Agenda
Planning Commission
City Of Edina, Minnesota
City Council Chambers

Subject: B-24-05 Front yard setback variance request for 6716
Arrowhead Pass

Subject: B-24-05, A plan modification for an 85.9-foot front yard setback variance granted in 2021 from the required 103.2 feet for a 17.3-foot front yard setback for property located at 6716 Arrowhead Pass.

DATE: 7/2/2024
TO: Liz Olson – Administrative Support Specialist
FROM: Ben Jore, PE – Senior Project Engineer
RE: **6716 Arrowhead Pass - Variance Review**

STORMWATER AREA CALCULATIONS:

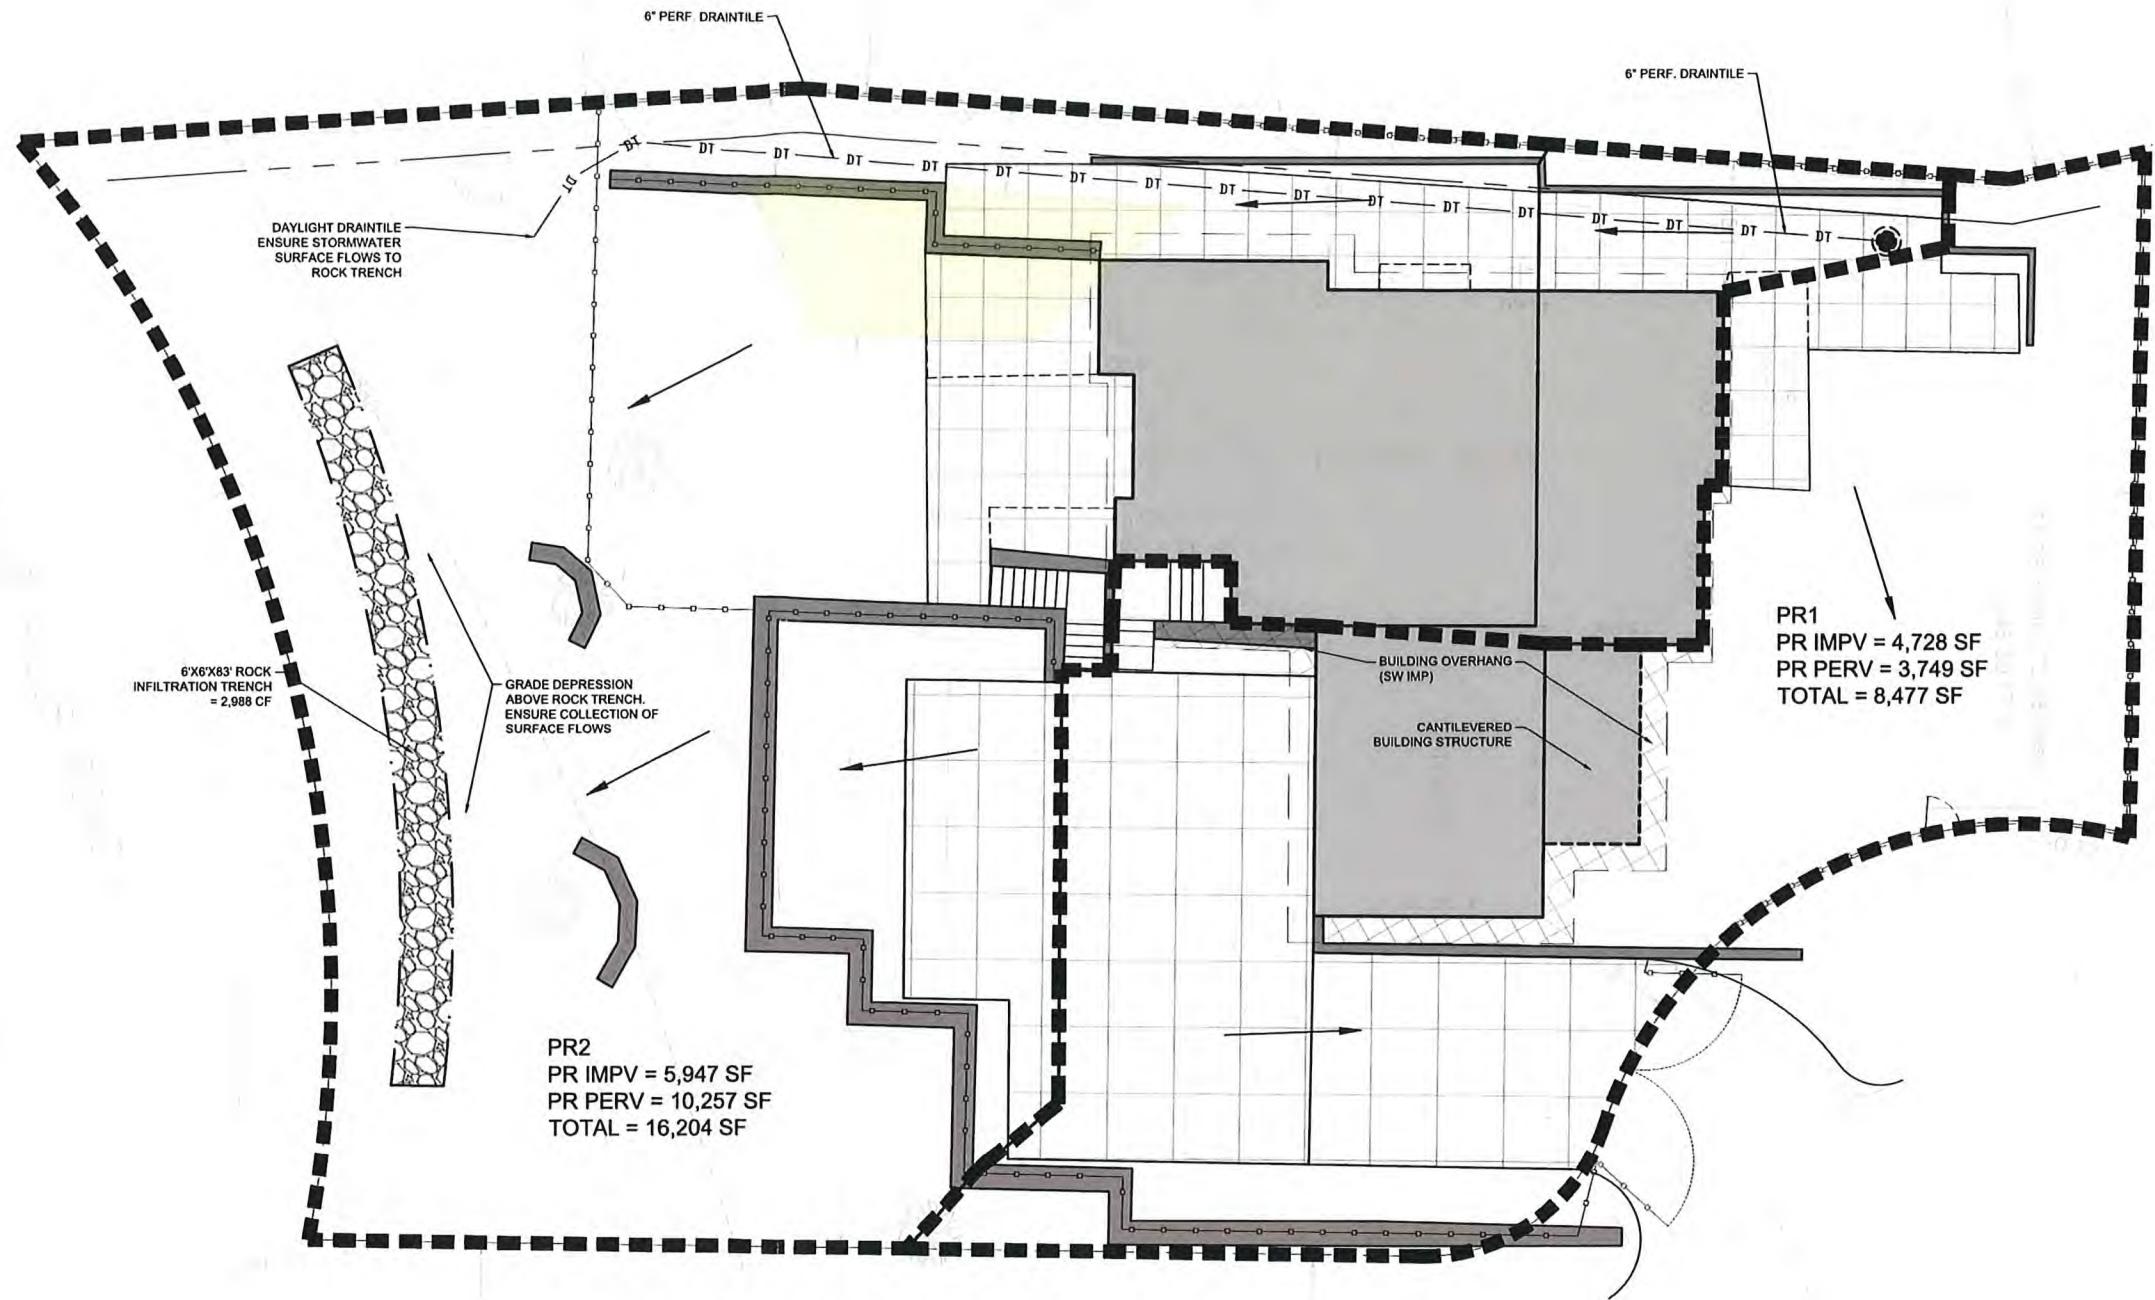
Site drains to a structural flooding issue prior to draining to Nine Mile Creek. It does not appear that any additional impervious will drain to private property.

The project increases the impervious surfaces by over 600sf and drains to a structural flooding issue. Stormwater mitigation is required. The project currently is proposing a rock trench to provide volume control. The stormwater report has been submitted and complies with the City stormwater policy.

Floodplain is located in the front of the property however the project does not impact the floodplain.

An updated Nine Mile Creek Watershed District permit is required or documentation that one is not required.
